### **Remarks**

Drawings: Replacement/Annotated Sheets

Annotated Sheet

Fig. 2.

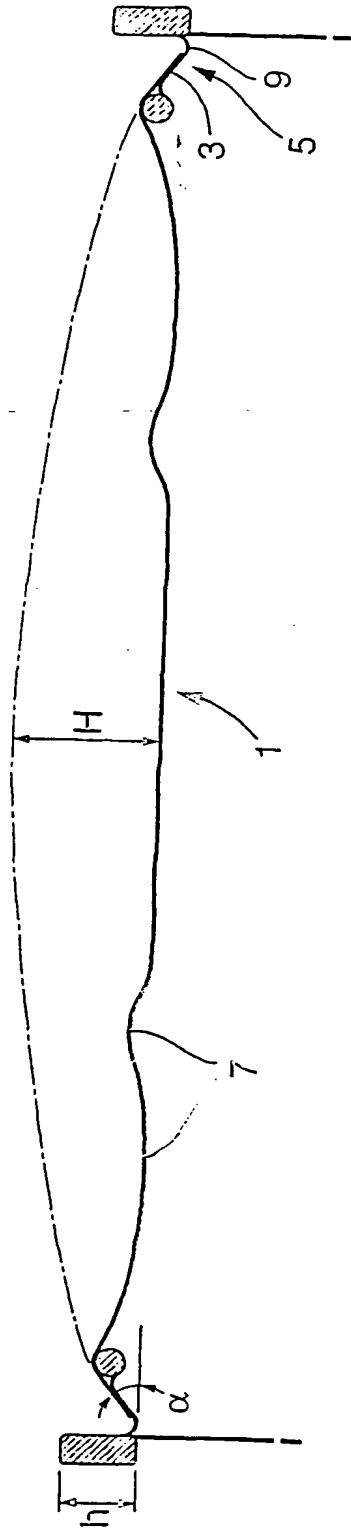
After reconsidering the application prior to receipt of the first Office Action, the principals noted an obvious error in Figure 2 which is described at paragraph **[0022]** as follows:

**[0022]** In figure 2, it can be seen that the seal surface is inclined at angle  $\alpha$  (alpha) which is greater than the foil tangent angle  $\beta$  (beta). This eliminates the peel component and maximises bond failure pressure.

In original Figure 2 the angle  $\alpha$  (alpha) is obviously less than the angle  $\beta$  (beta). In the Replacement Sheet the angles of Figure 2 have been changed to correspond to the description at paragraph **[0022]** and new Figure 2 correctly reflects angle  $\alpha$  (alpha) being greater than angle  $\beta$  (beta).

The changes in Figure 2 do not involve new matter and simply correspond the angles in Figure 2 to the description in paragraph **[0022]**.
